Exception Request No.: 55
Section: WBR3
Town: Thornton
Highway: US 3 (Tier 2)
Station: 1919+43 to 1927+37
Drawing No.: WBR3042-01 and WBR3042-02; WBR3C 152
Survey Report Cross Reference No.: WBR3 C147 to C149
Exception Type: HDD Pits within Pavement
HDD Alignment Passing Under Pavement

Summary of Justification for Exception

NPT
UNDERGROUND ALIGNMENT
TRENCHLESS CROSSINGS
SCALE: 1" = 30'
DATE: 10/7/2016

DES: CHK:
DRW: APR:
TOWN:
TRANSMISSION LINE:
WBR3
SHEET
WBR3042-1

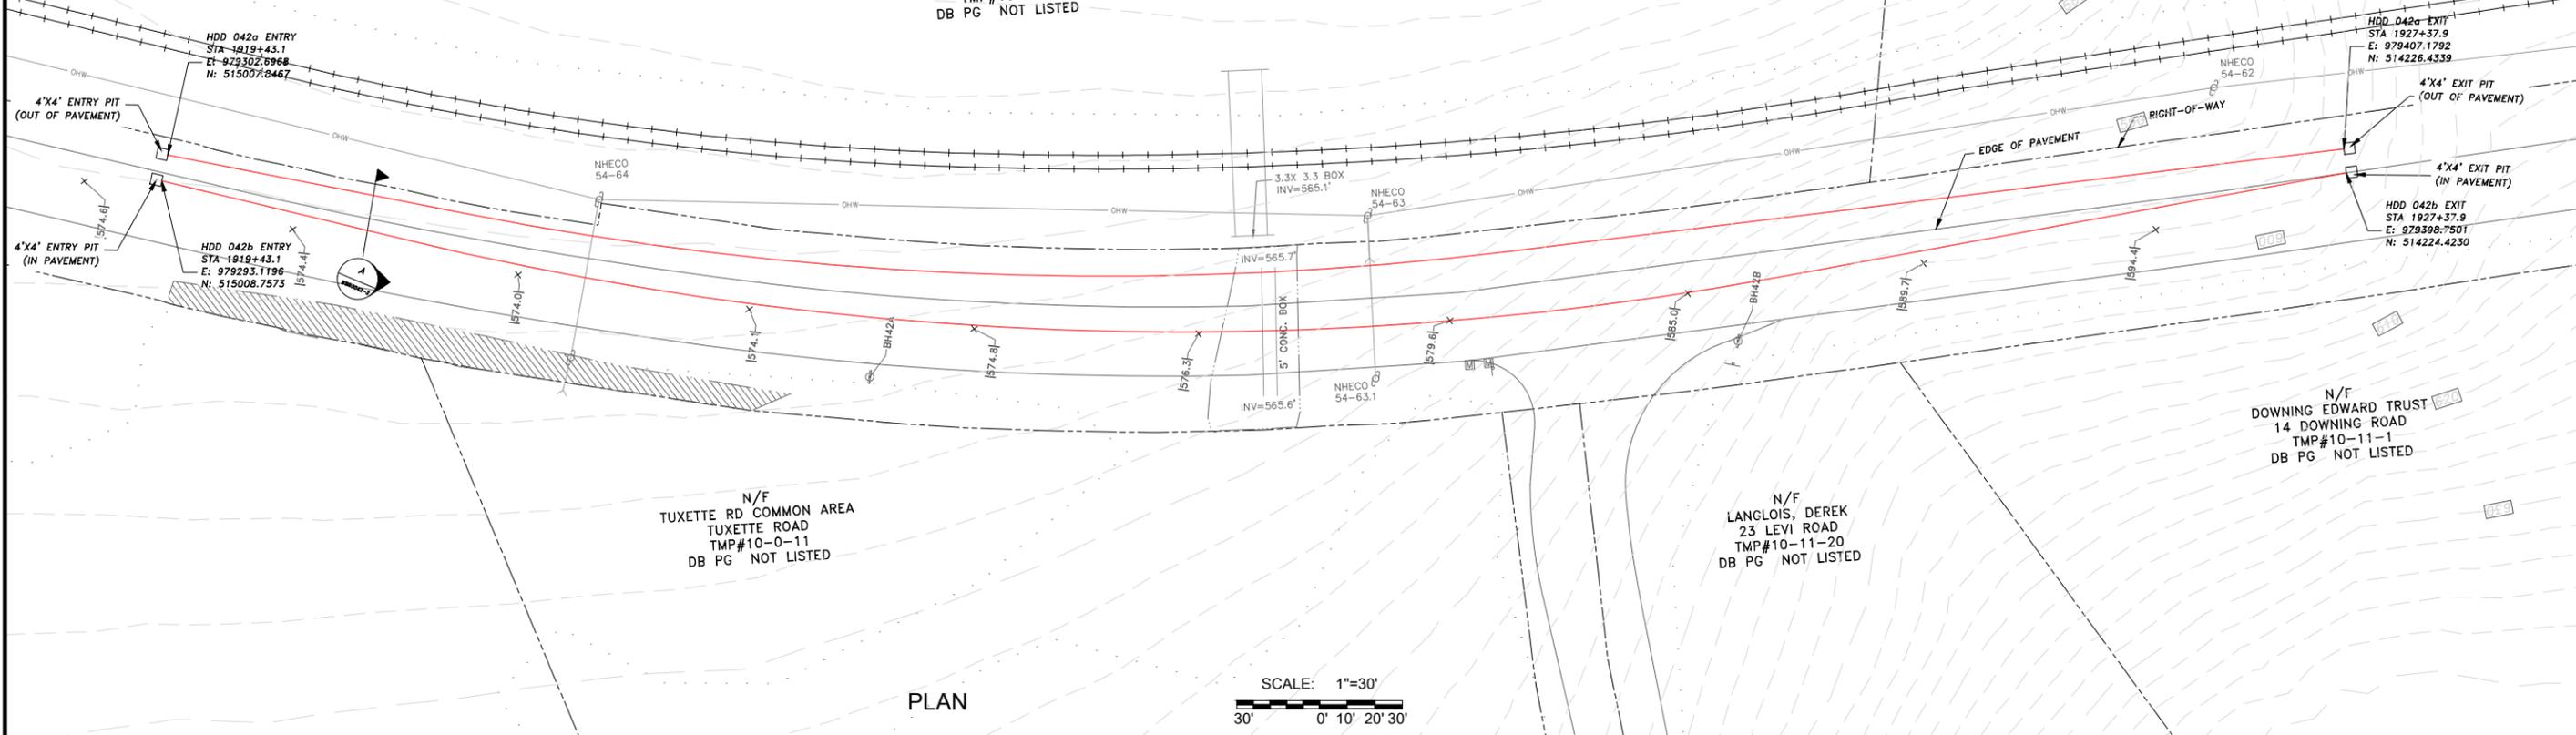
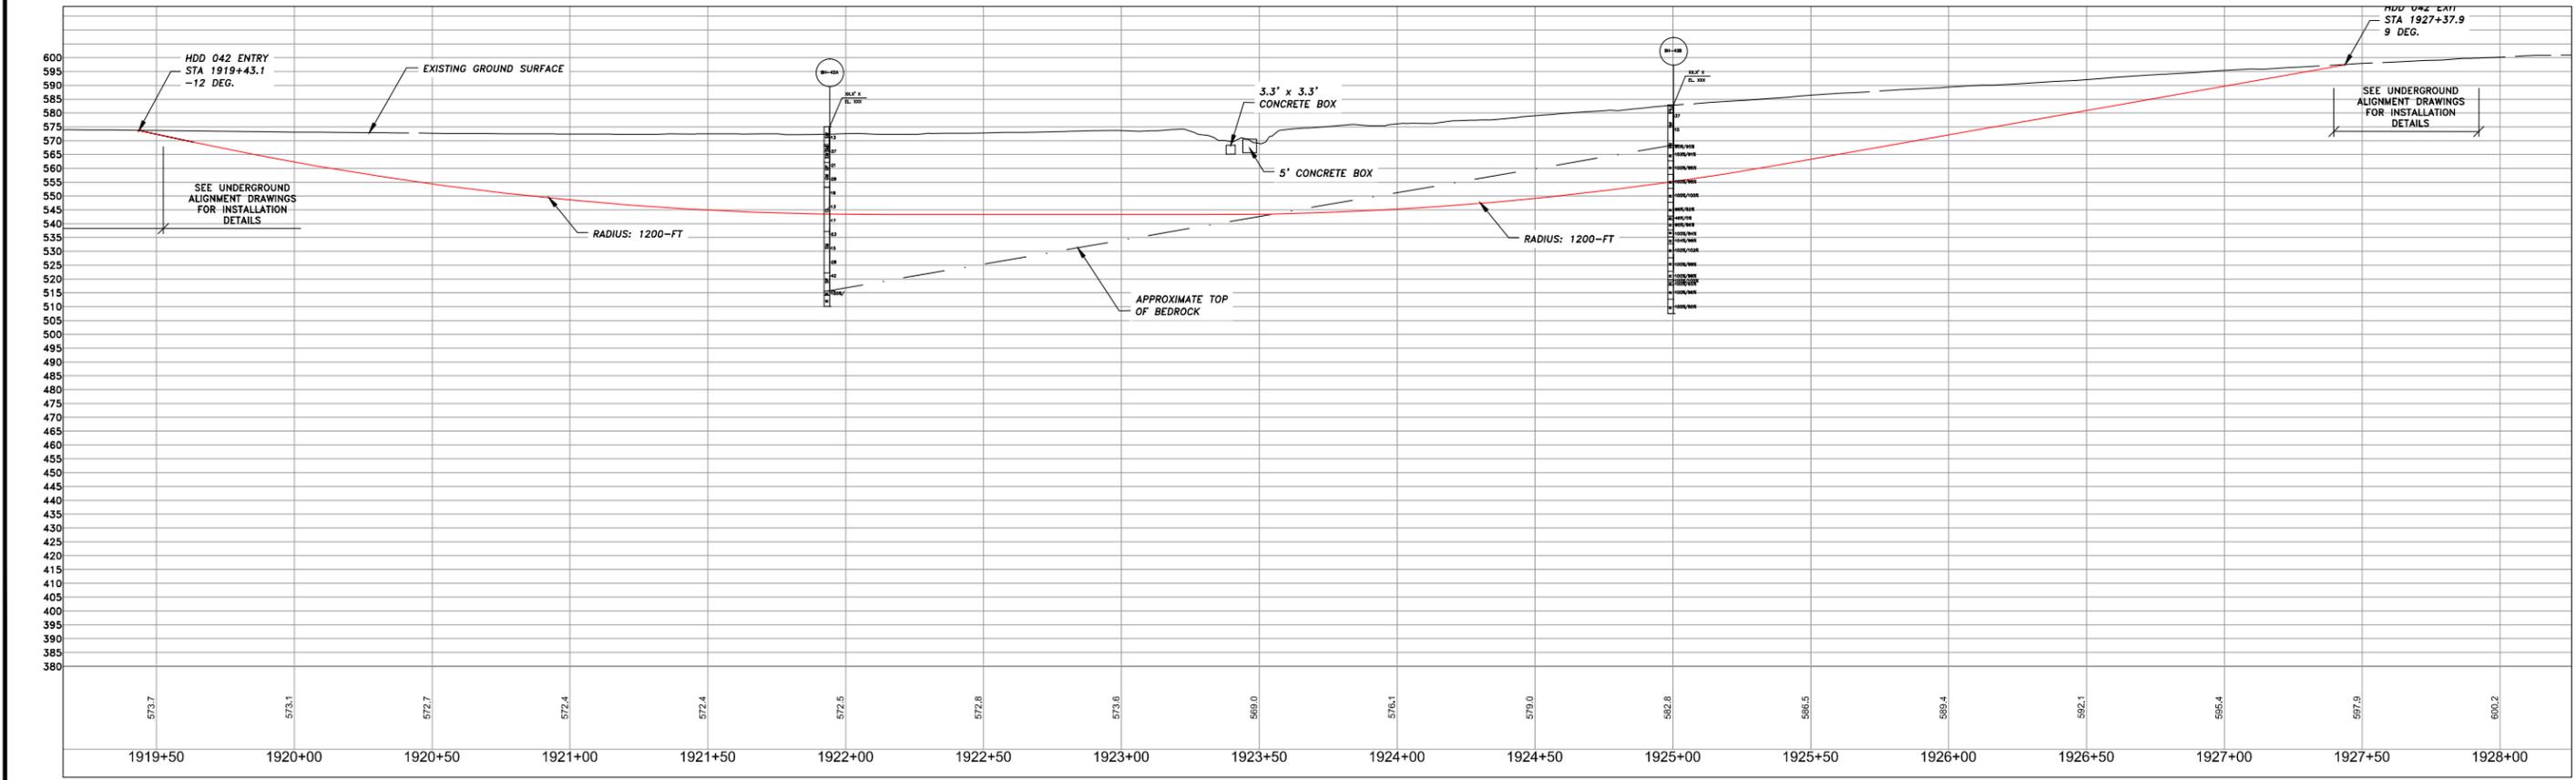
The alignment of the cable system adjacent to the entry location is on the east side of US 3. The HDD 042 entry location is located on the east side of US 3 due to the availability of work space in this area and to address the NHDOT's comment to avoid road crossings where feasible. (See photograph #1 of entry location in Exhibit A and Sheet WBR3042-01). The west side of US 3 is occupied by wetlands.

The HDD 042 exit is located on the east side of US 3. (See photograph #2 of exit location in Exhibit A and Sheet WBR3042-1) Moving the HDD exit to the west side would require additional tree cutting, and an open-trench road crossing (and NHDOT exception approval for such a crossing).

WBR3C152

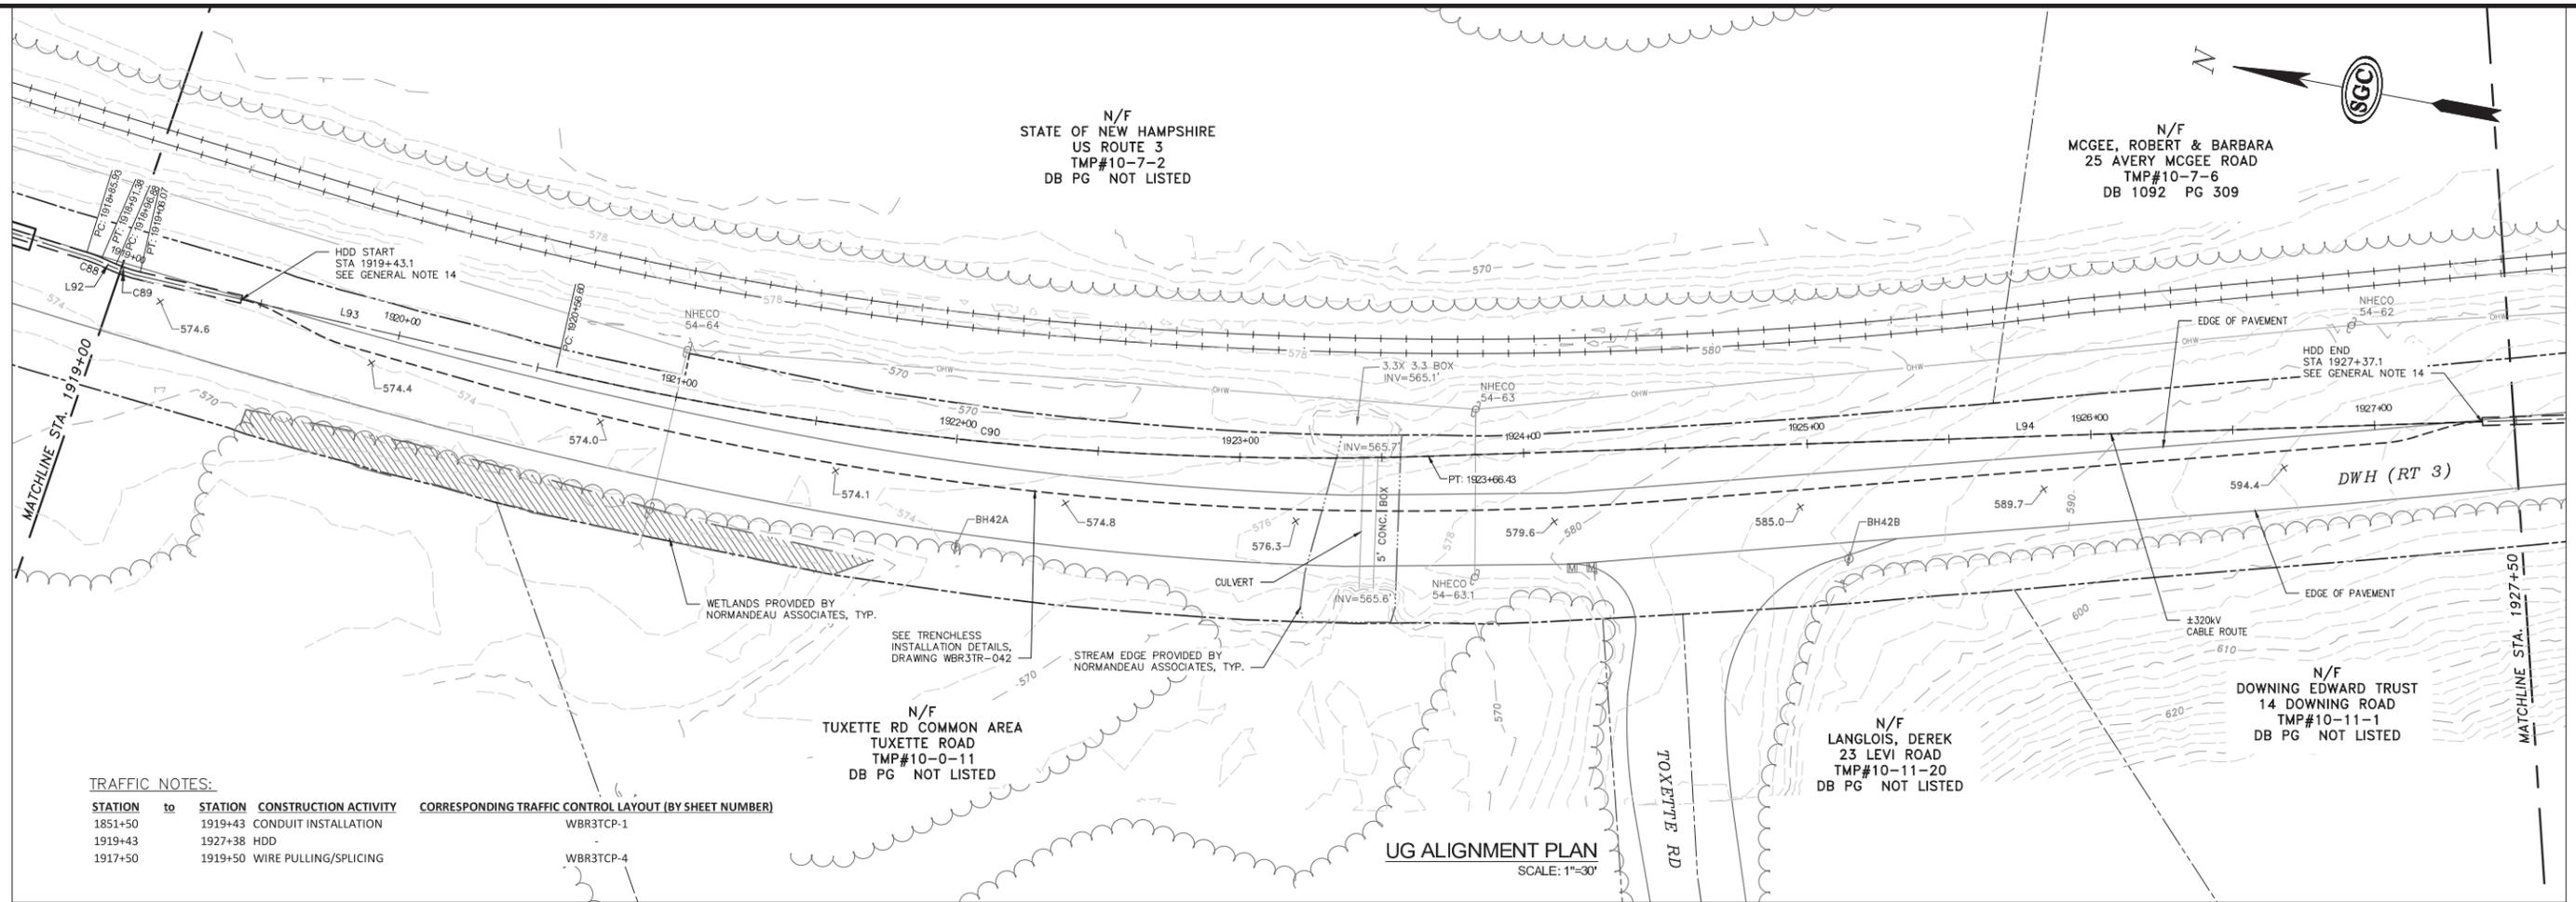
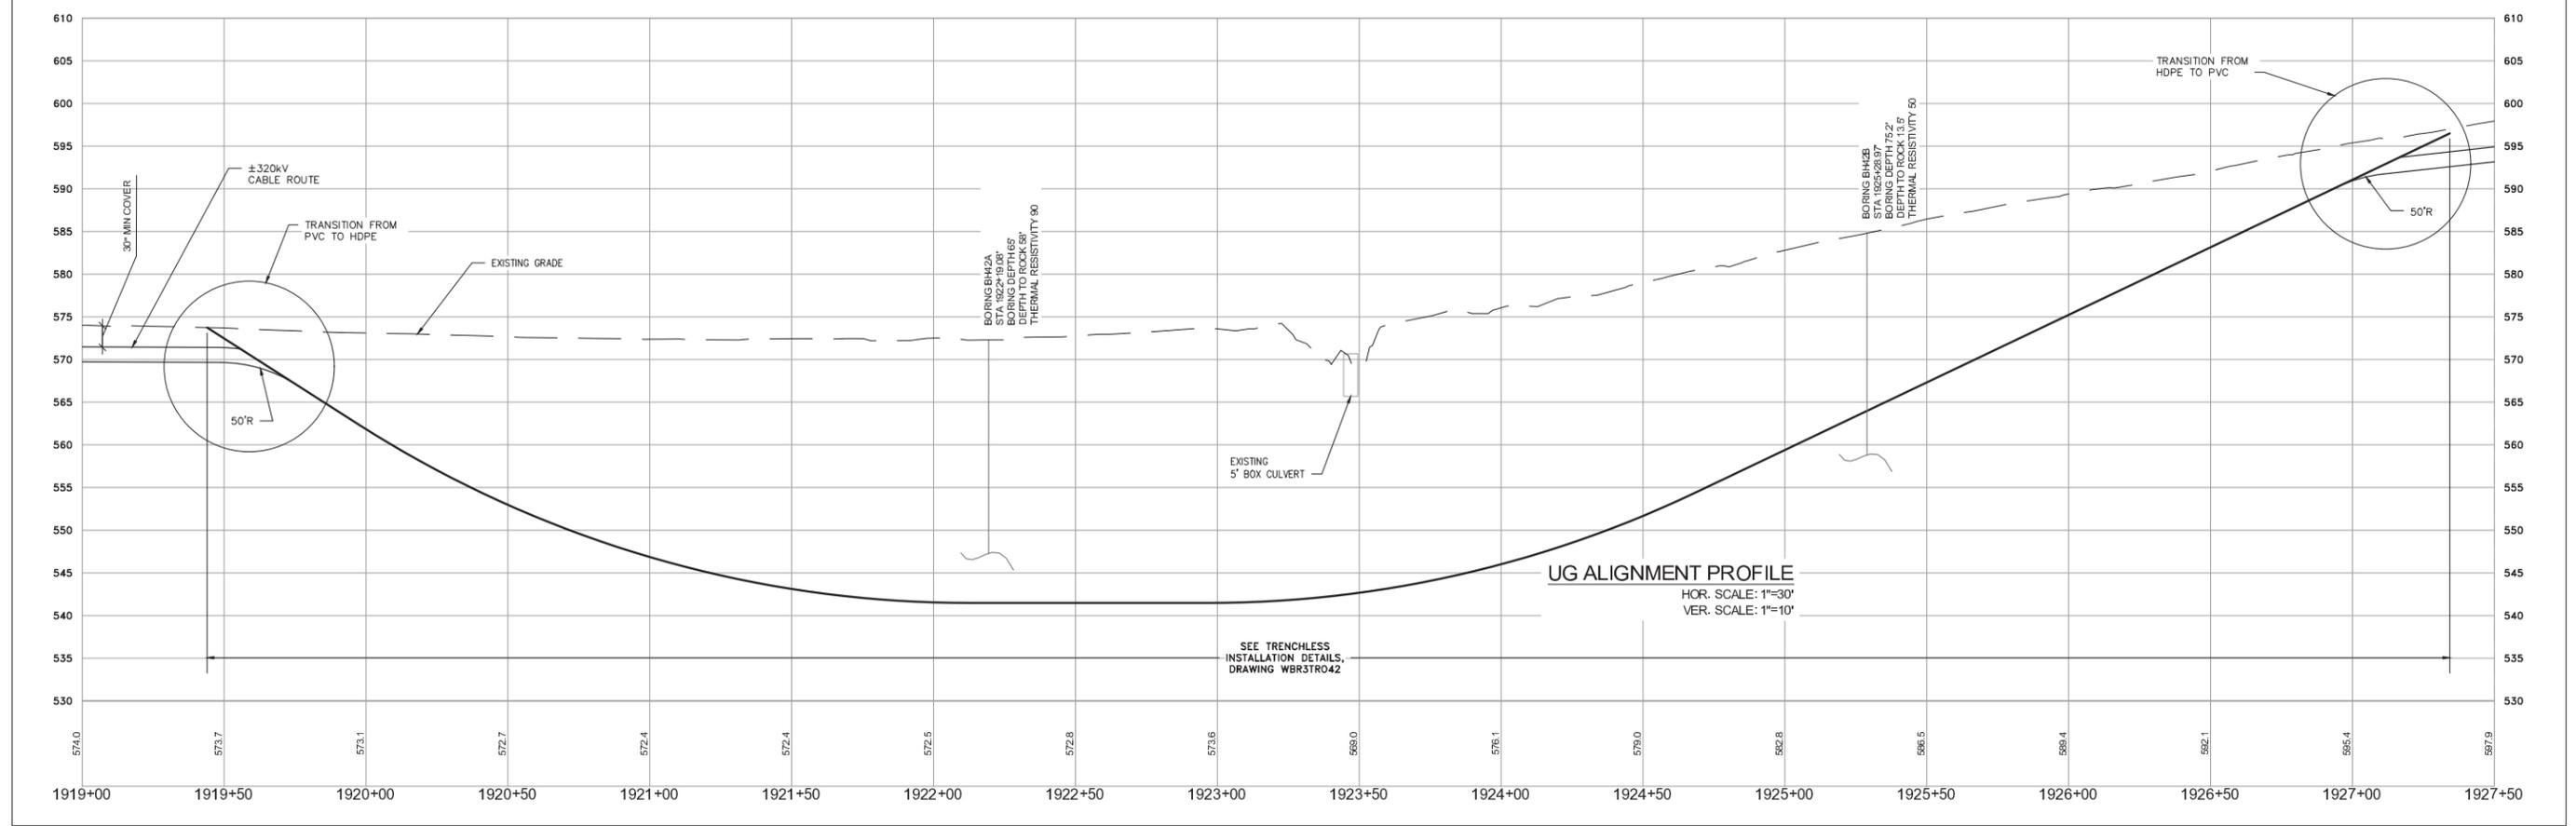
From Station 1919+43 to 1927+37, one or both of the bore paths are located beneath the pavement, as shown in drawings WBR3C152 attached. The distance between the edge of US 3 pavement and the ROW (plan distance) is approximately 12 to 20 feet on either side of the road. With two (2) bores spaced at 20 feet and an offset of 5 feet from the ROW, it is not possible to avoid drilling beneath the pavement at this location.
